## SITE PLAN REVIEW AND APPEARANCE BOARD STAFF REPORT

307 NE 5<sup>th</sup> Avenue

Meeting	File No.	Application Type
September 27, 2023	2022-151-SPF-SPR-CLV	Class V Site Plan
Property Owner	Agent	
Sir 1 Development LLC	David Karam; Gregory Jones

Consideration of a Class V Site Plan application, including a Landscape Plan and Architectural Elevations, for a three-story, 5-unit townhouse development.

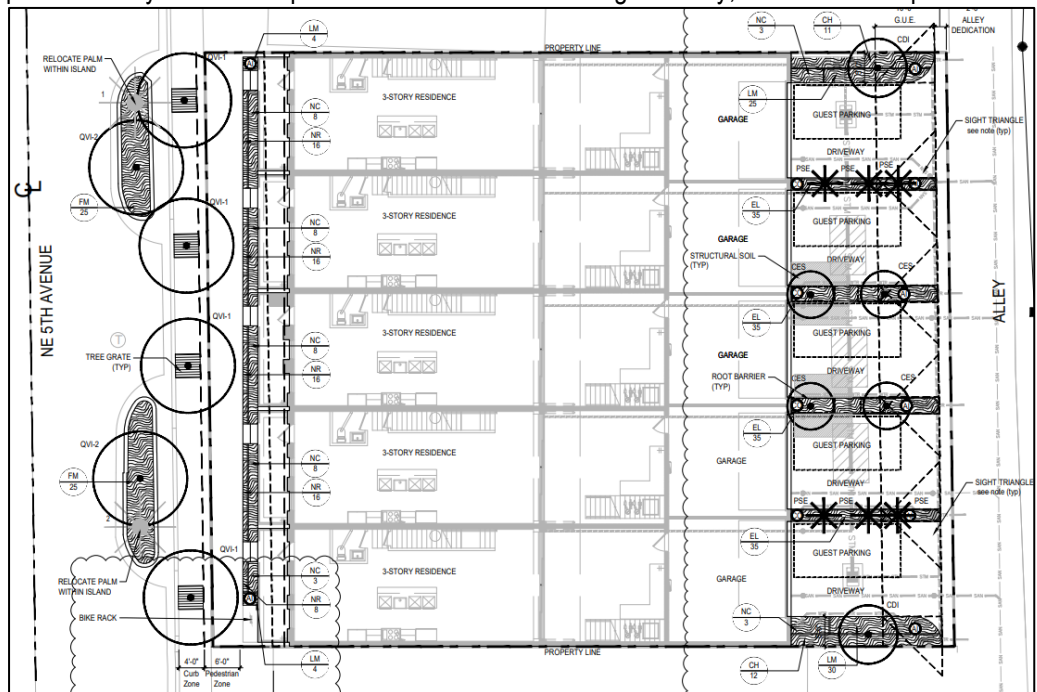
The proposed development incorporates many elements of the Masonry Modern architectural style outlined in the Delray Beach CBD Architectural Guidelines. That being said, there are certain aspects of the design that, if improved, would benefit the composition to be more consistent in keeping with the proposed style and the intent of the Criteria for Board Action.

The front elevation is more characteristic of a commercial building rather than a residential building. The way in which the projecting stucco banding/pilaster is integrated into the design results in a front façade that appears overtly heavy and does not represent the overall function typically intended for residential development. For example, the design of a residential building, particularly in the downtown area, would typically accommodate balconies or terraces. Balconies and terraces are not only an amenity to the residents, but also add interest to the overall design and façade that break up the mass. A reduction in the thickness of the elements and inclusion of balconies may benefit the design. Furthermore, the elevations illustrate a 2-inch depth difference between materials (stucco and wood), however the front façade would benefit from a greater differentiation between the materials. By instilling a more dynamic break between the stucco and wood, more movement would be introduced across the façade that would relieve the sense of flatness that is currently communicated in certain areas of the design.

In addition, the design communicates elements reflective of an office building. The monotonous color palette of gray, white, and black may serve to reinforce this disconnect. Certain design language utilized reinforces the sense that the design is more

reminiscent of buildings typically intended for a use other than residential. Specifically, the repetition of the window pattern, absence of balconies, and design of the projecting canopies, allude to a commercial or office type building. While the stoops and front door design elements identify that this is a residential structure, in their absence the top half of the composition does not clearly communicate the intended use.
